# UNITED STATES PATENT AND TRADEMARK OFFICE

APPLICATION NO.	FILING DATE	FIRST NAMED INVENTOR	ATTORNEY DOCKET NO.	CONFIRMATION NO.
10/662,707	09/15/2003	Masaki Terashima	32758US6	1017
116	7590	03/28/2006		
PEARNE & GORDON LLP			EXAMINER	
1801 EAST 9TH STREET			LOBO, IAN J	
SUITE 1200				
CLEVELAND, OH 44114-3108			ART UNIT	PAPER NUMBER
			3662

## DETAILED ACTION

FIG. 21

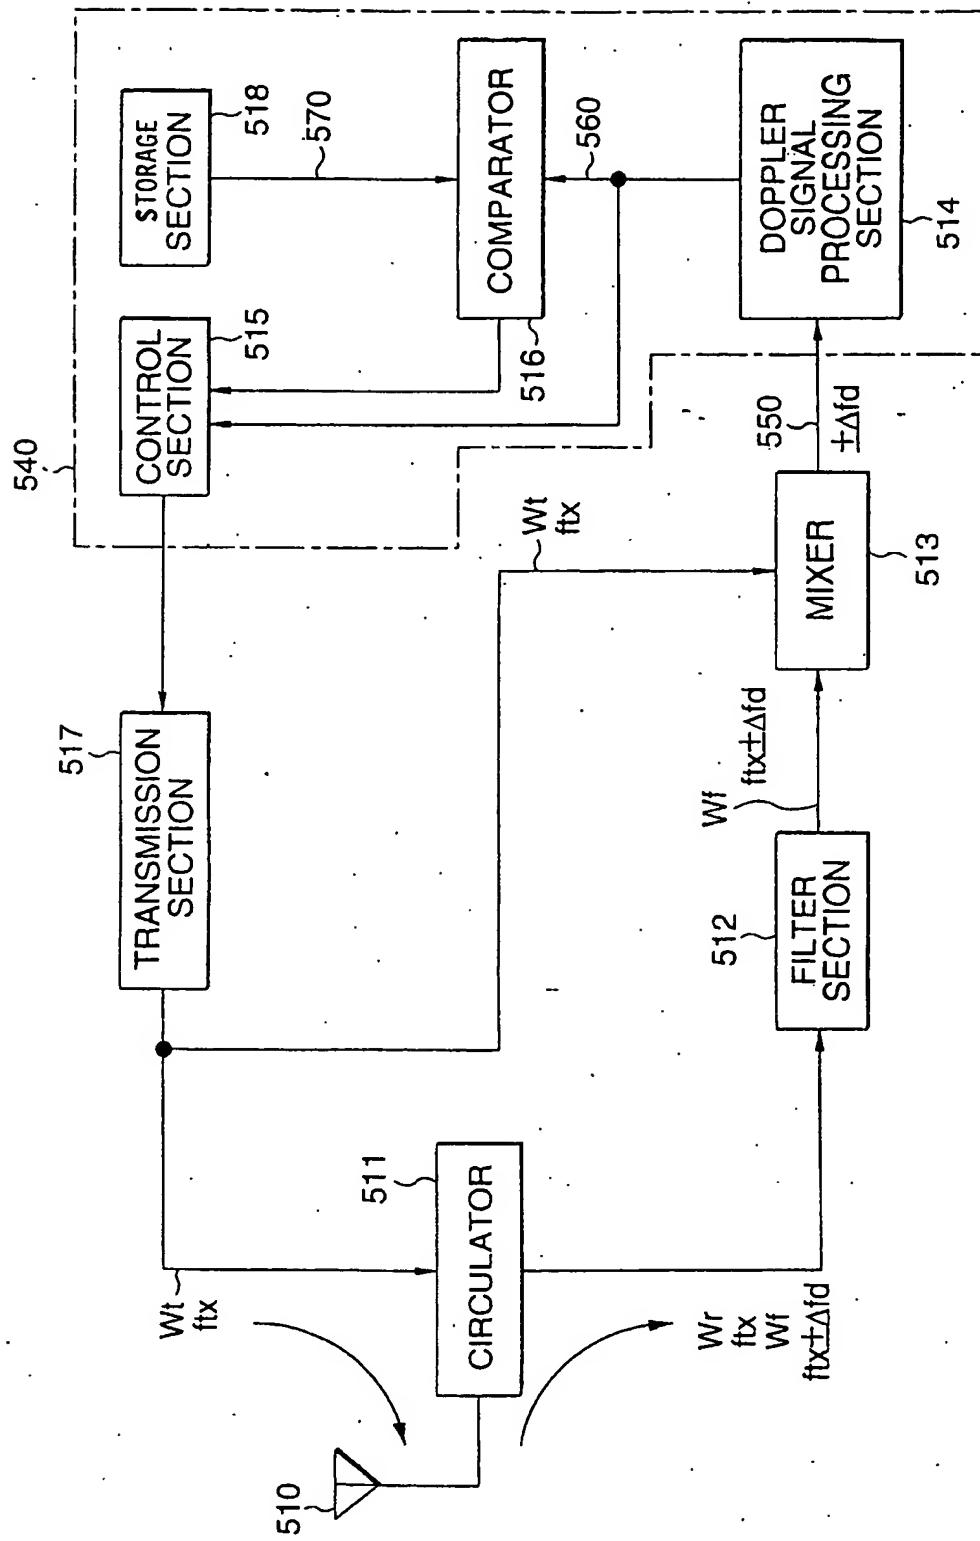
1. The drawings are objected to because in Fig. 21, box 540 has not been identified in the specification, specifically at page 49, lines 12-21. Further, "warning signal 580" (page 50, line 14) is not shown in Fig. 21. Corrected drawing sheets in compliance with 37 CFR 1.121(d) are required in reply to the Office action to avoid abandonment of the application. Any amended replacement drawing sheet should include all of the figures appearing on the immediate prior version of the sheet, even if only one figure is being amended. The figure or figure number of an amended drawing should not be labeled as "amended." If a drawing figure is to be canceled, the appropriate figure must be removed from the replacement sheet, and where necessary, the remaining figures must be renumbered and appropriate changes made to the brief description of the several views of the drawings for consistency. Additional replacement sheets may be necessary to show the renumbering of the remaining figures. Each drawing sheet submitted after the filing date of an application must be labeled in the top margin as either "Replacement Sheet" or "New Sheet" pursuant to 37 CFR 1.121(d). If the changes are not accepted by the examiner, the applicant will be notified and informed of any required corrective action in the next Office action. The objection to the drawings will not be held in abeyance.
